ROUTE 90 IMPROVEMENTS STUDY

Phase 3 Public Engagement Summary

Objective: Provide three lanes in each direction

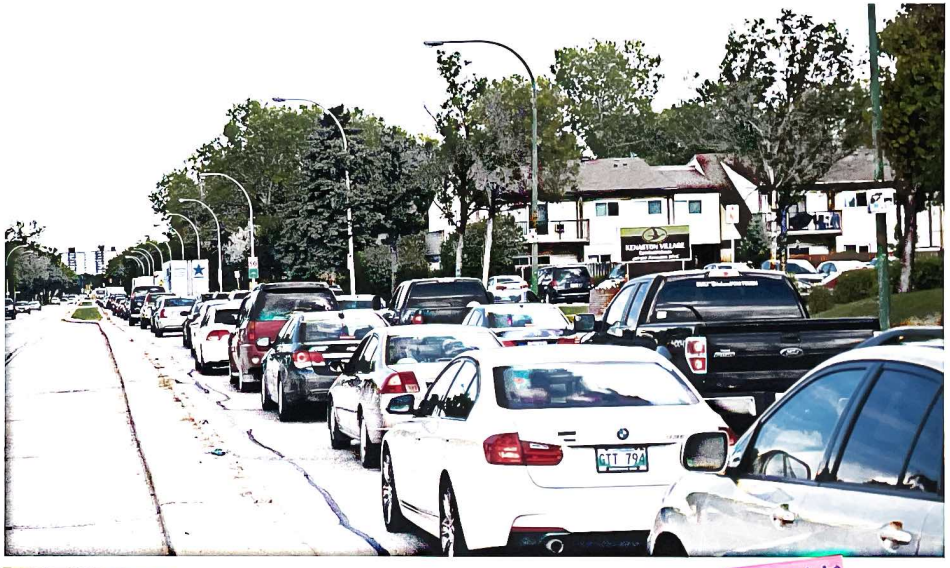
Province of Manitoba is already planning a freeway. Highway expansion - Why spend so much money for a measly 3,000 trucks? √√

Too many trucks on Rte 90. They need to be diverted to the Perimeter unless serving the immediate area

Objective: Improve opportunities for transit, pedestrians and cyclists

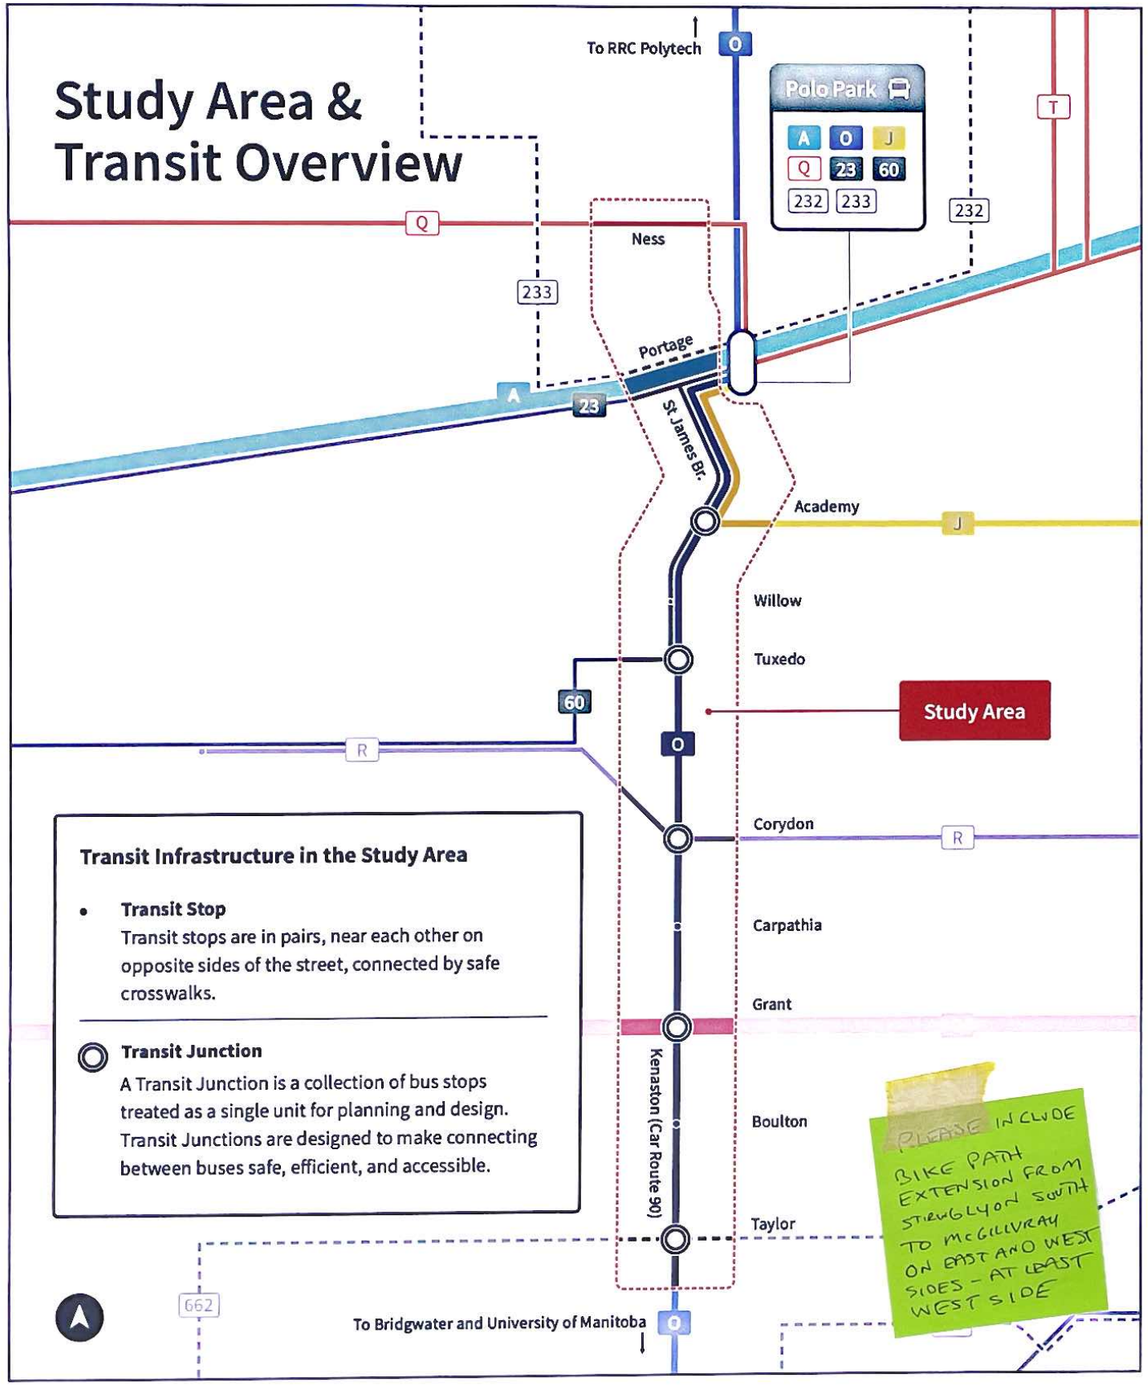
Many better spent on expanding rapid transit master plan!
